<b>AMENDMENT OF SOLICITATION / MODIFICATION OF CONTRACT</b>			1. Contract Number <b>DCKA-2015-B-0068</b>	Page of Pages 1   23
2. Amendment/Modification Number  <b>Amendment 4</b>	3. Effective Date  See Box 16C	4. Requisition/Purchase Request No.	5. Caption <b>Rehabilitation of Pennsylvania Bridge over Rock Creek and Rock Creek Parkway</b>

14. Description of Amendment/Modification (Organized by UCF Section headings, including solicitation/contract subject matter where feasible.)  This amendment is issued to:  1. Respond to questions from prospective bidders (6 pages) 2. Delete specification pages 31 and 32 and replace with pages 31R and 32R attached 3. Delete drawings G-5 and G-7 and replace with pages G-5R and G-7R attached 4. Delete note TCN-01 and replace with TCN-01R 5. Delete pay item pages 1-11 and replace with pay item pages 1R-11R attached				
Except as provided herein, all terms and conditions of the document is referenced in Item 9A or 10A remain unchanged and in full force and effect.				
15A. Name and Title of Signer (Type or print)		16A. Name of Contracting Officer Courtney B. Lattimore Contracting Officer		
15B. Name of Contractor  (Signature)	15C. Date Signed	16B. Di

SUGGESTED STAGING SECTIONS AND DETAILS

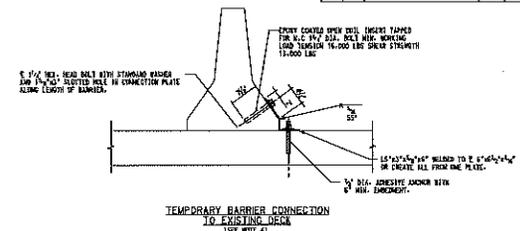
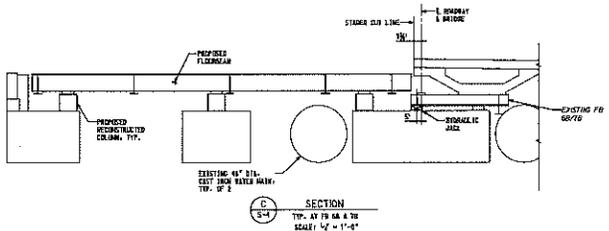
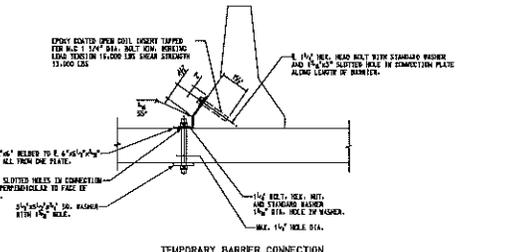
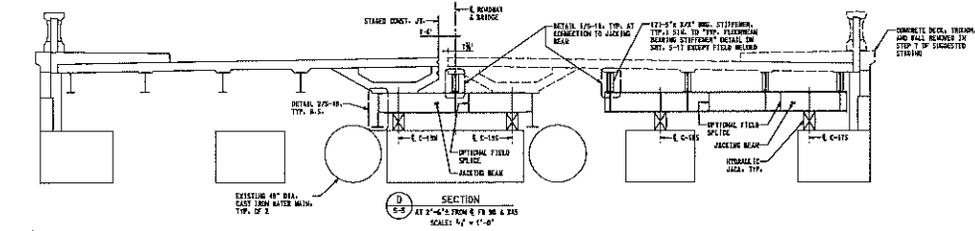
20. On sheet S-7, Note 7 says the contractor is responsible for supporting the existing water main. On numerous other pages, it is acknowledged that the existing water main is self-supported. Please confirm that the existing water main is self-supporting.

**Response:** The existing water mains are self-supporting. Note 7 on Dwg. S-7 will be revised via Amendment.
